PLANNING COMMISSION REGULAR TUESDAY, April 9, 2024 at 5:30 P.M. Hybrid Meeting

Planning Commission Regular Meeting
Date Of Planning Commission Meeting: April 9, 2024

ERB Review - Entrance Corridor Design Guidelines - The Verve, 100 Stadium Road, ERB review April 9, 2024

ELEVATION - EAST

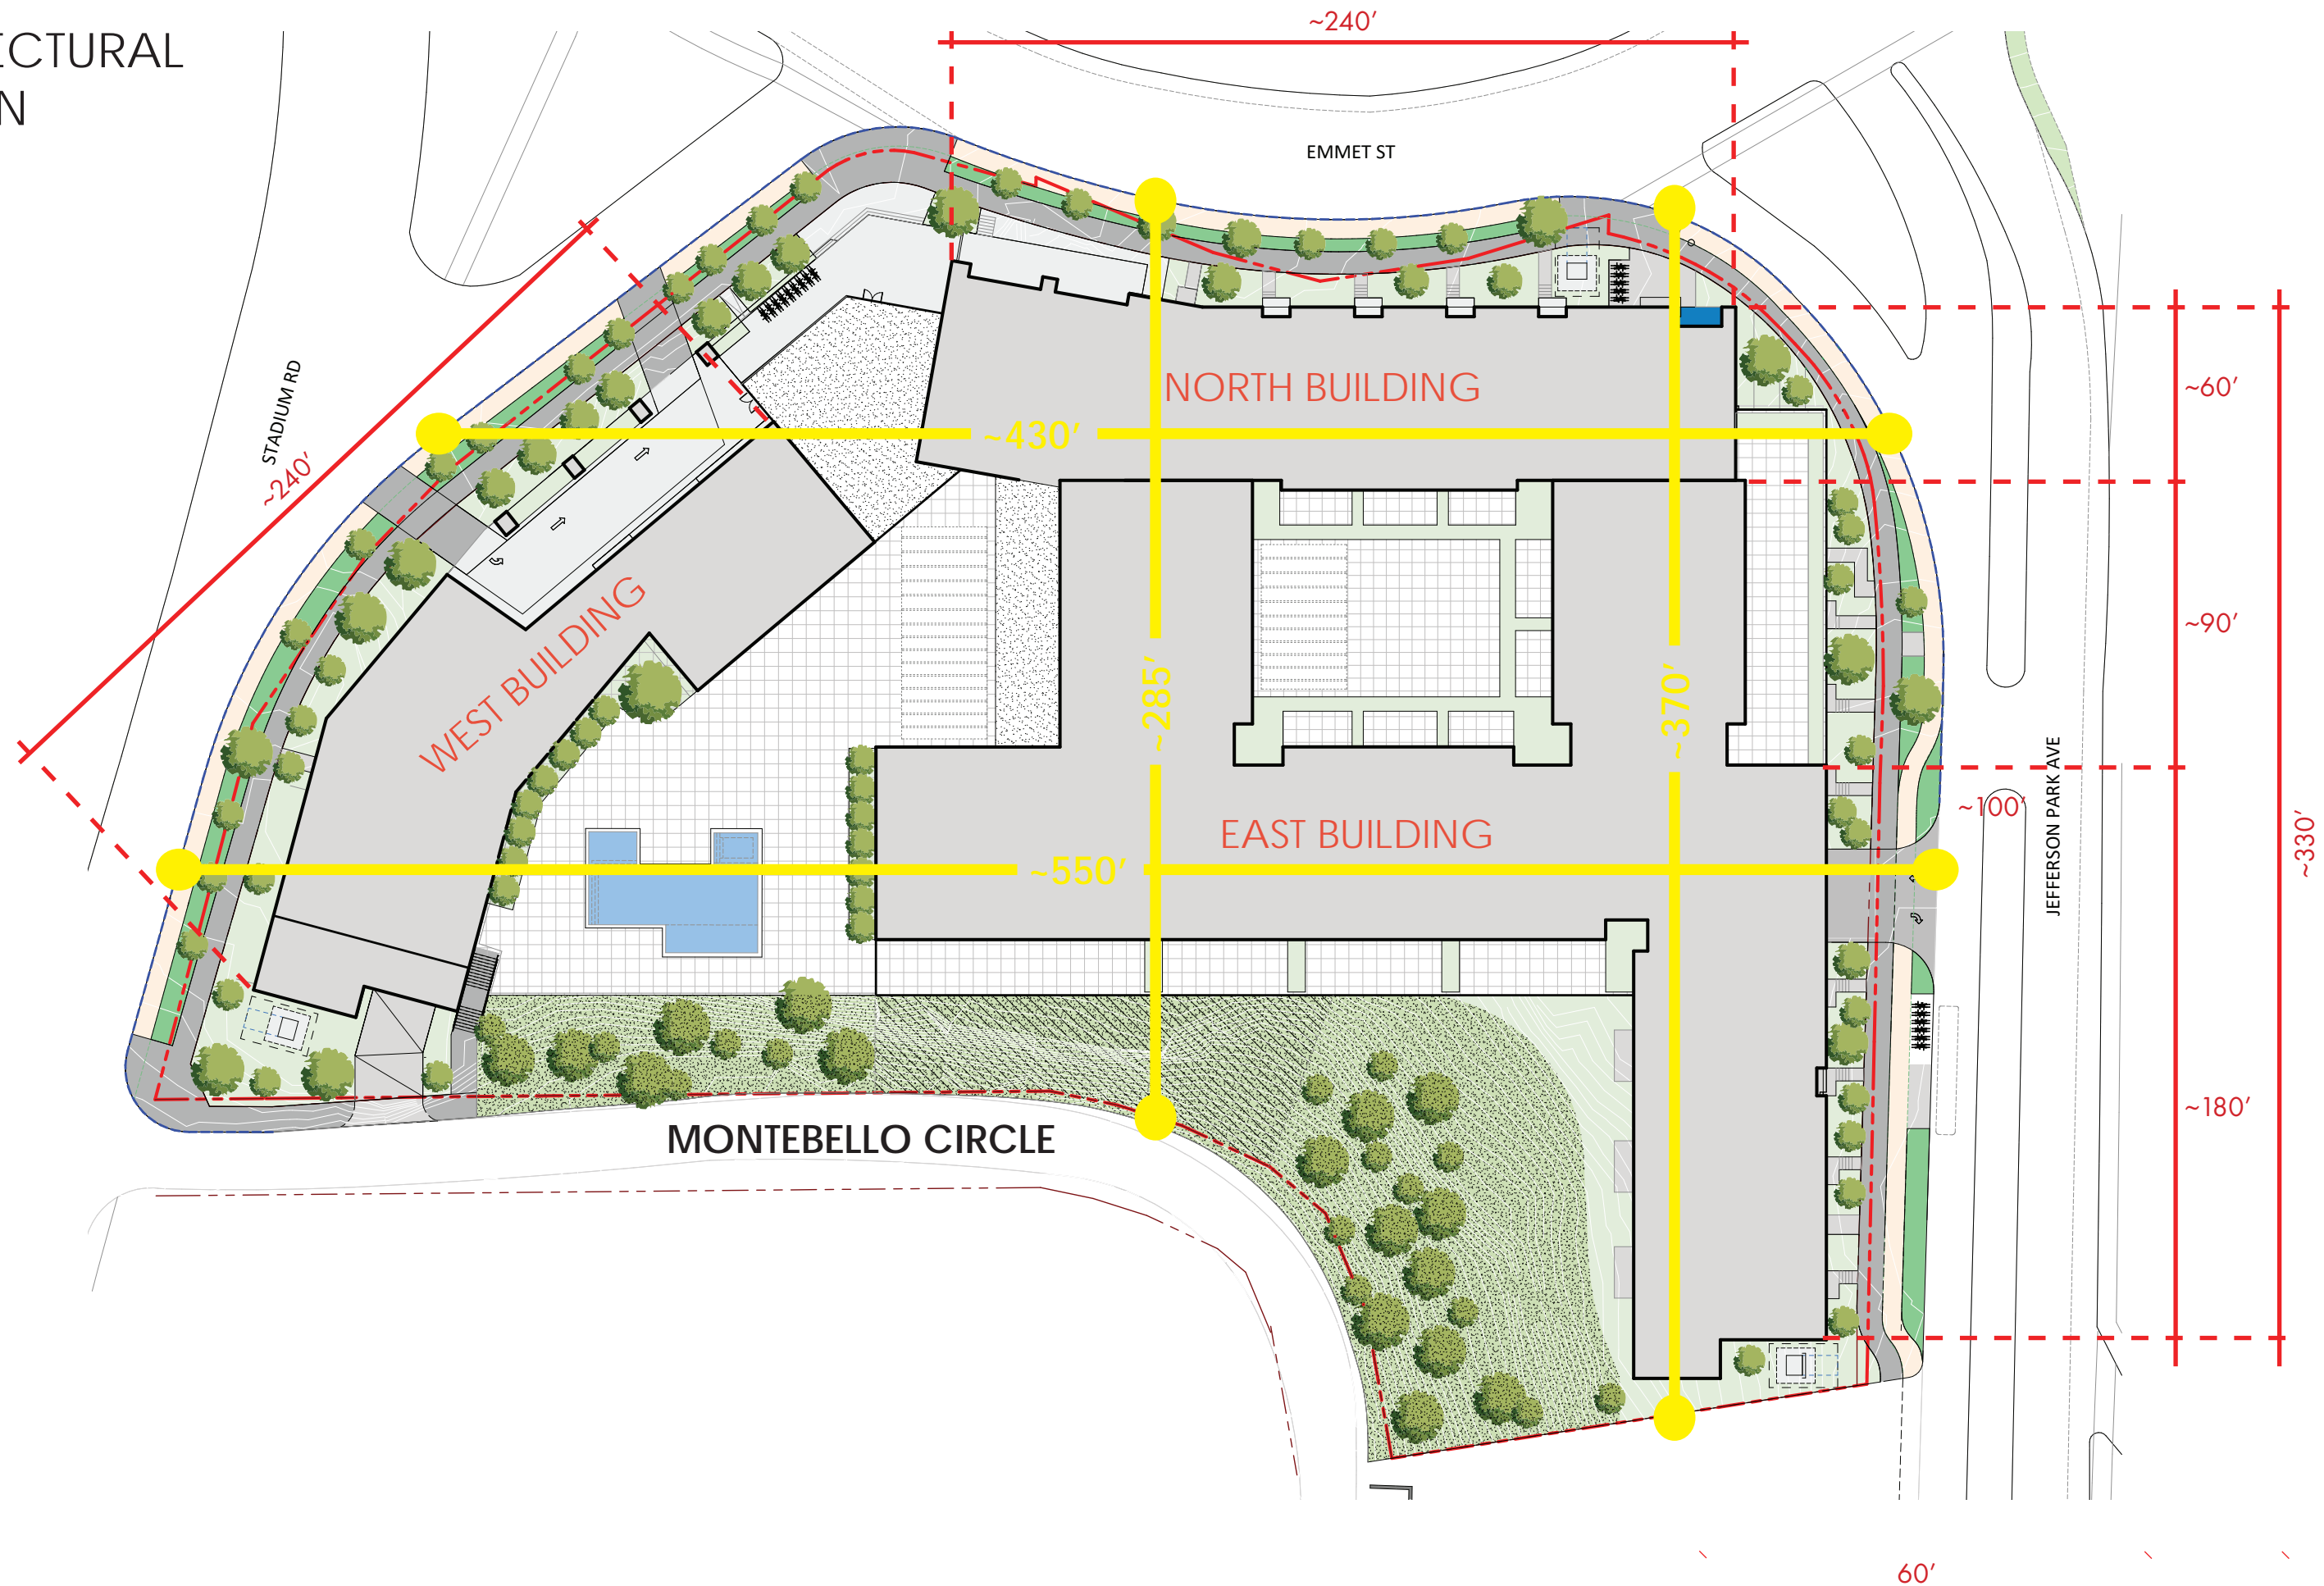
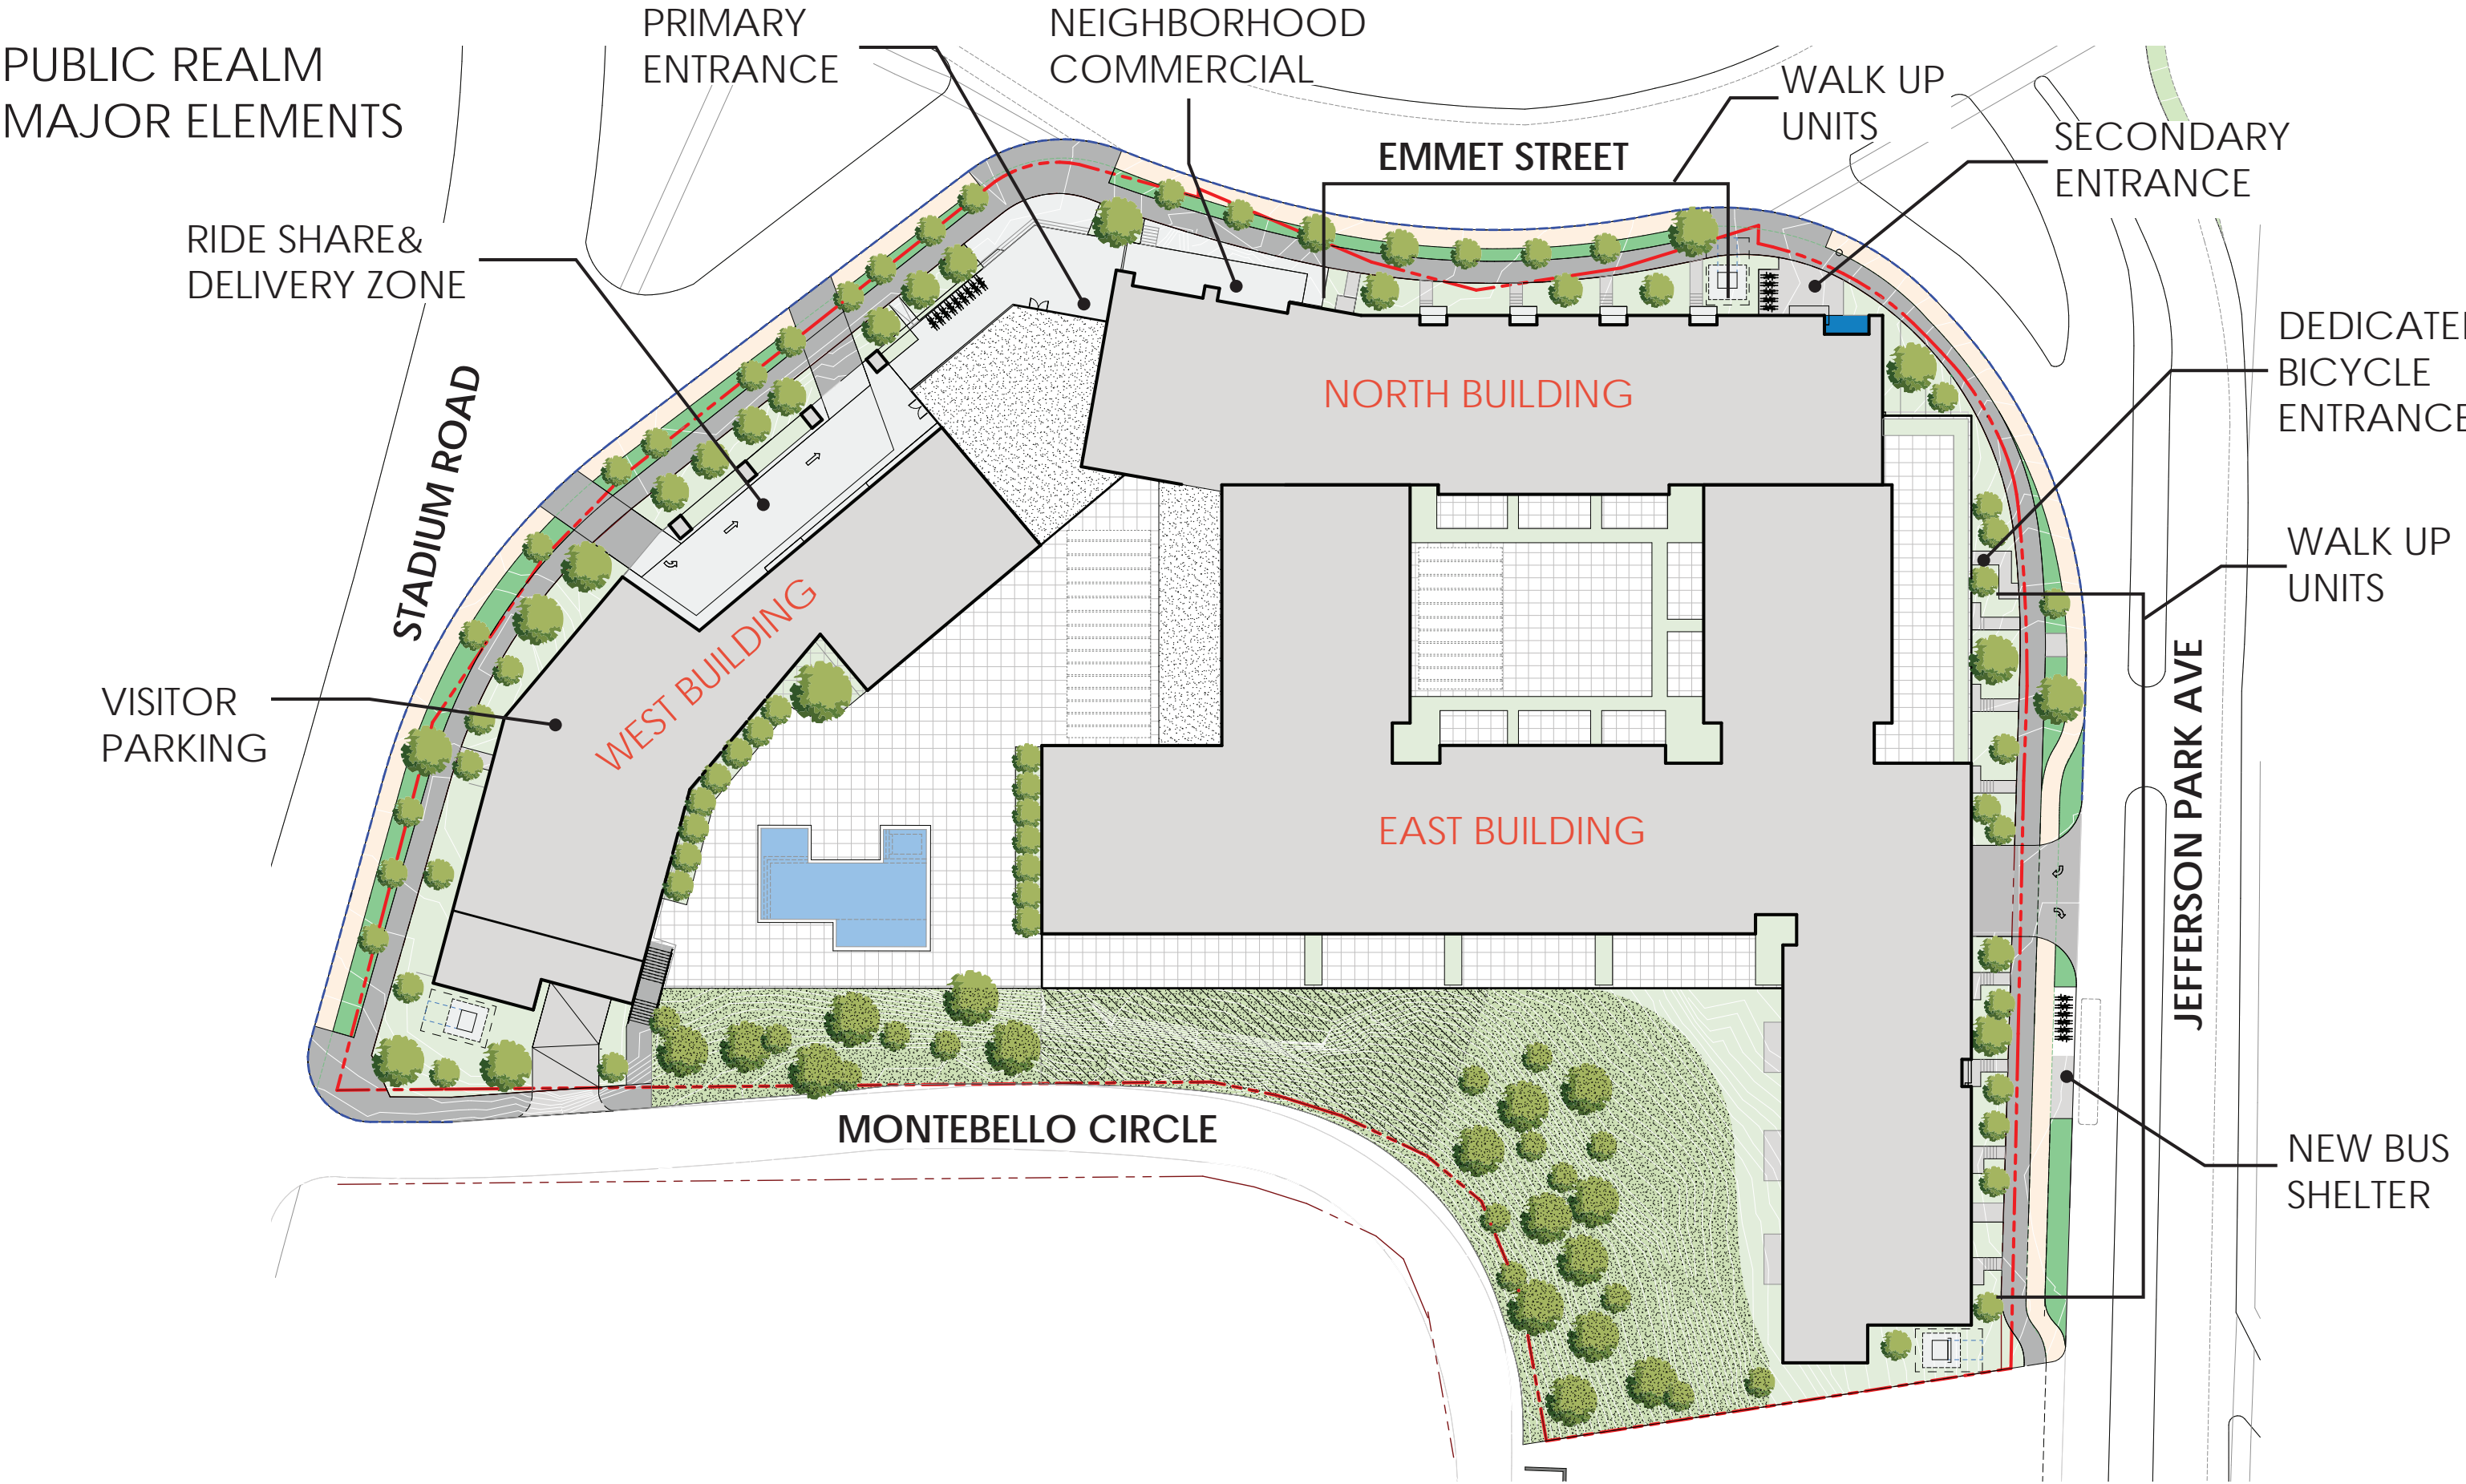
Wall detail: The ERB should discuss the vertical and horizontal lines of the EIFS panels, as indicated in the renderings (see below), and determine if there is a preference for the detail to be flush (flat with the wall) or proud (projecting from it, framing the EIFS panels), or some combination of both. The applicant expressed that this detail is not finalized, that the intent of illustrating the lines in the renderings was to communicate the *overall pattern of jointing* and the *mixture of the three tones of champagne colors*.

The guidelines do not recommend one or the other, only broadly suggesting that materials and elements offer texture and visual interest. The guidelines for details suggest the use of articulated elements and variations in the wall plane. The ERB should determine if those recommendations are achieved satisfactorily by other elements of this design, thus allowing flexibility to finalize this detail later, or if this detail must be clarified prior to approval of a CoA.

- [EIFS] (*Clarification of the joint detail.*)
